## DRAWING AMENDMENTS

#### REMARKS

# Device and Method for Protecting a Motor Vehicle Against Theft

Inventor: Ulrich Emmerling et al. Attorney Docket.: 071308.0549 Annotated Sheet 1/3

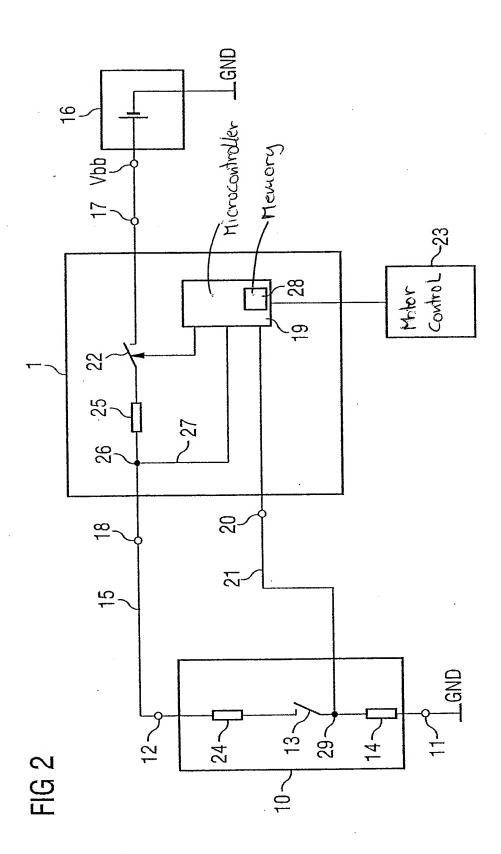
The drawings were objected to for failing to show every feature of the invention as specified in the claims. Please replace Drawing Sheet(s) 1-3, Figure(s) 1-3 with replacement Drawing Sheet(s) 1-3. Applicants also submit annotated red-lined drawing pages reflecting the changes. Applicants provide formal corrected drawings to be entered if the proposed changes are accepted by the Examiner.

Examiner has objected to the drawings for not showing every feature of the invention specified in the Claims under 37 CFR 1.83(a). Applicants submit that the diagnosis and evaluation unit is shown in Fig. 2 with element 19. Element 19 can for example be a microcontroller which performs the functions of the diagnosis and evaluation unit as described in the specification of the present application, therefore, all claimed limitations are shown in Fig. 2.
